U.S. NUCLEAR REGULATORY COMMISSION  
REGION I

Report No. 030-05470/87-01

Inspection Summary: Closeout inspection conducted on January 21, 1987 (Report No. 030-05470/87-01)

Attachment 1 - Diagram of Plot Locations at Alpha, New Jersey

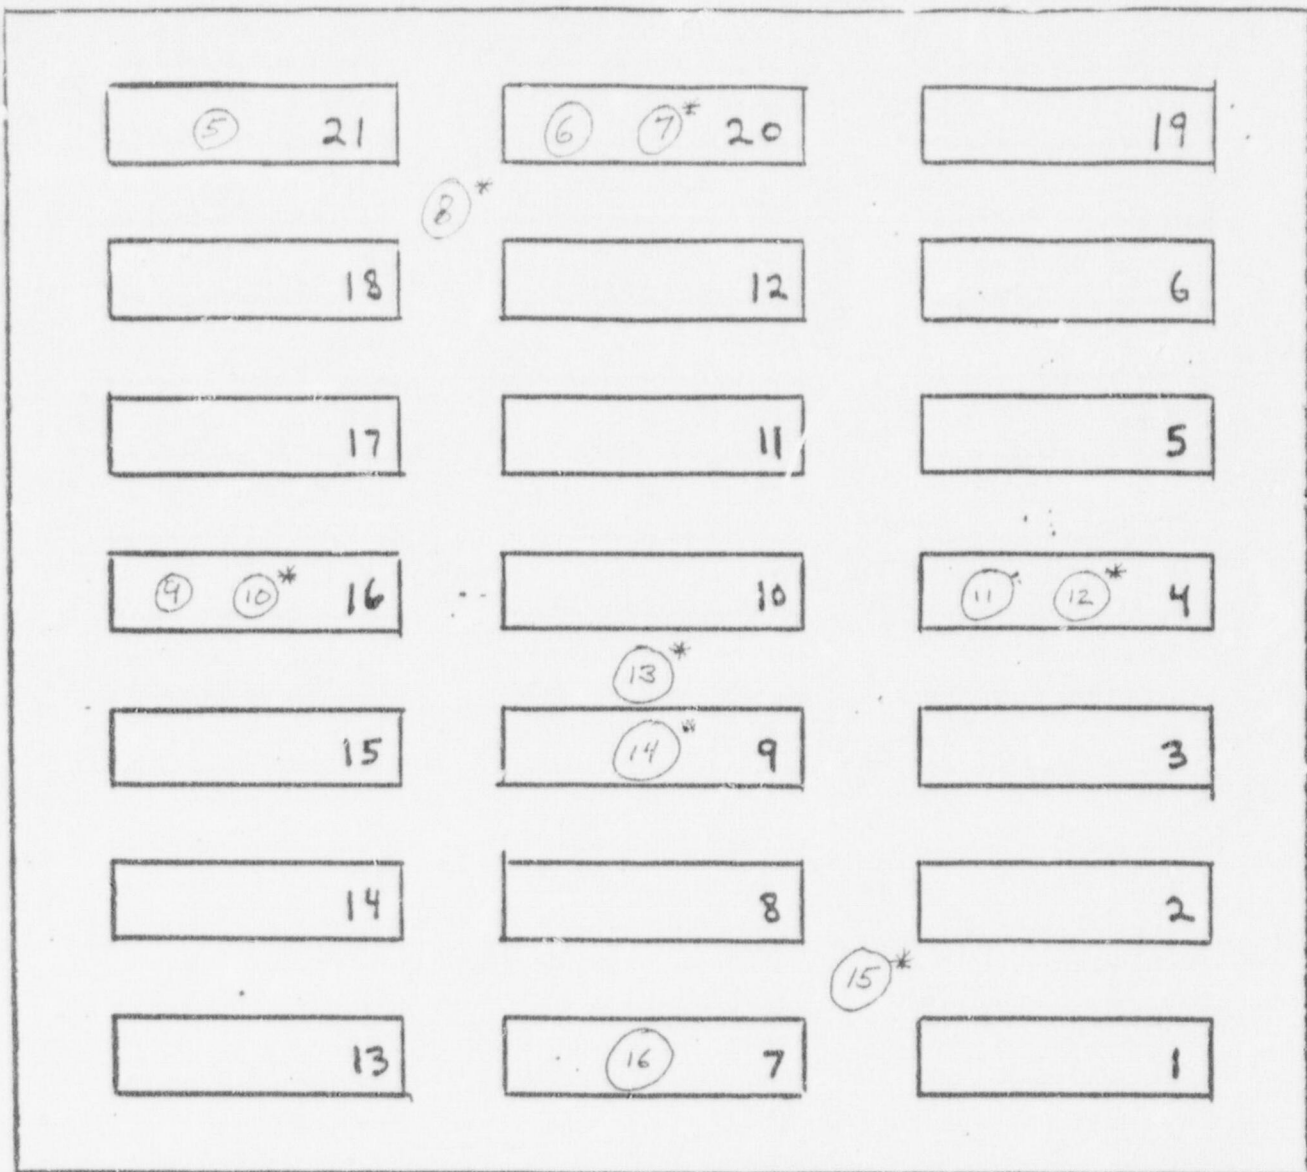
Results: The licensee's survey, enclosed with their letter dated November 18, 1986, does not accurately reflect the condition of the areas of the field site surveyed in that carbon-14 in excess of natural background is present in the areas sampled. The highest concentration found was 340 picocuries of carbon-14 per gram of soil.

Locations sampled in the 30'x70' field site are identified in Attachment 1. One combined vegetation sample was taken from various plants throughout the area. A total of 18 soil samples including surface and 6" Core Samples were taken in the area and like samples were combined such that eight separate analyses were performed. The composition of the combined samples and the liquid scintillation analysis results are given in Attachment 2. The licensee's letter dated November 18, 1986, states that no carbon-14 in excess of natural background was found in their samples. As Attachment 2 indicates, up to 340 picocuries of carbon-14 per gram of soil were found in the NRC samples.
